**ADDENDUM 1 TO
RFP R0066040
JANITORIAL SERVICES**

ADDENDUM 1

ENGINEERING SUPPORT BUILDING #23

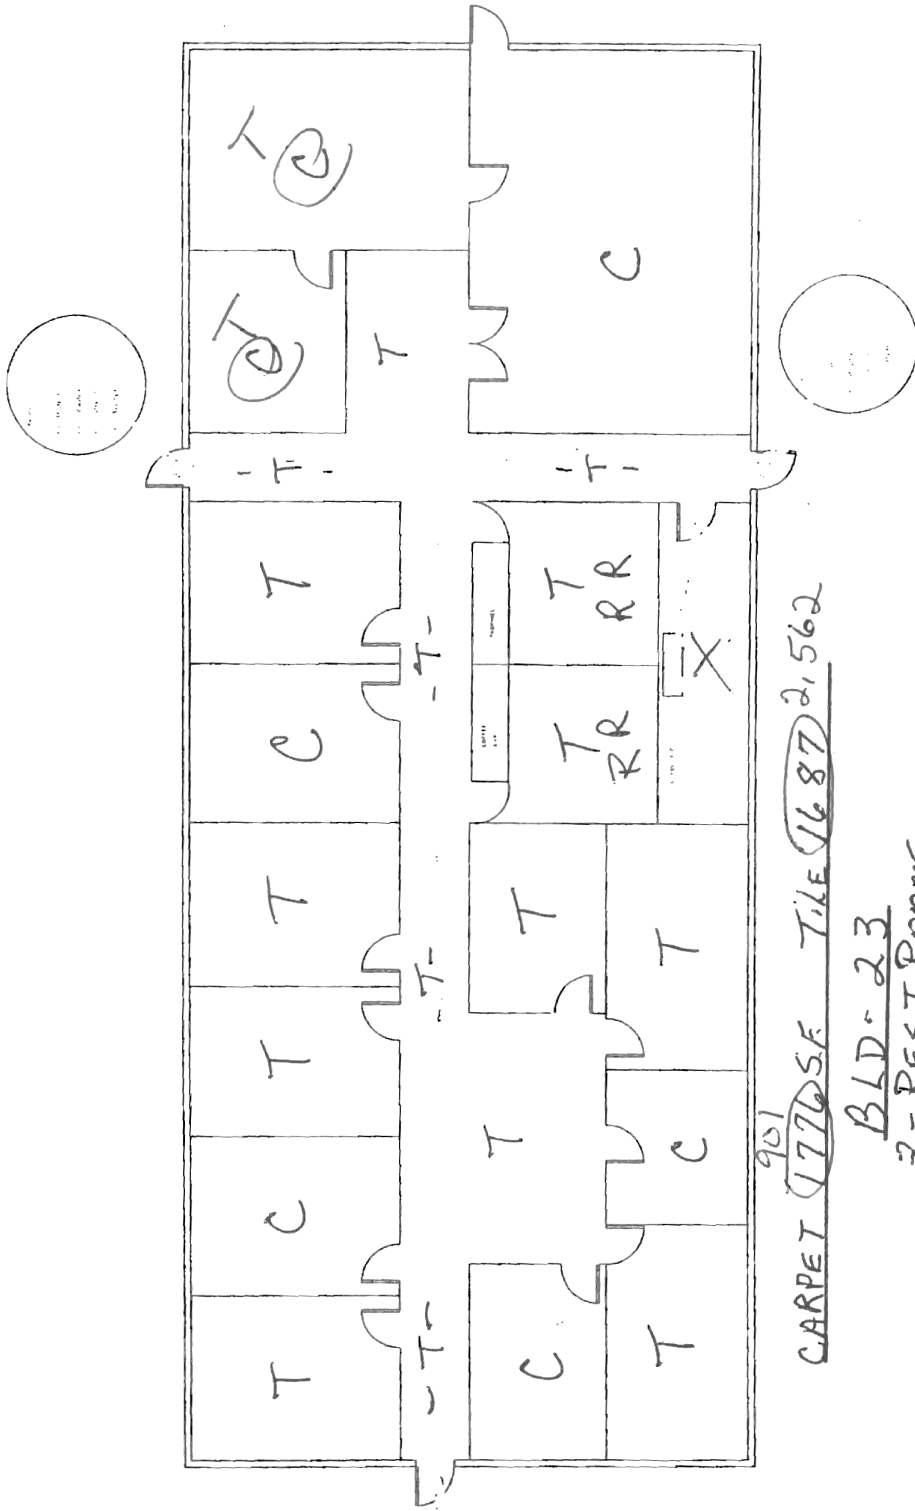
Building 23 – Engineering Support

Carpet Sq Ft: FROM 1,776 TO 901

Tile Sq Feet: FROM 1,687 TO 2,562

2) REPLACE:

Attachment A – Appendix 2 – Building Sketches, page 6 of 9 with attached revised sketch reflecting the carpet (C) and tile (T) square feet.

CARPET 901 1770 SF TILE 1687 2,562
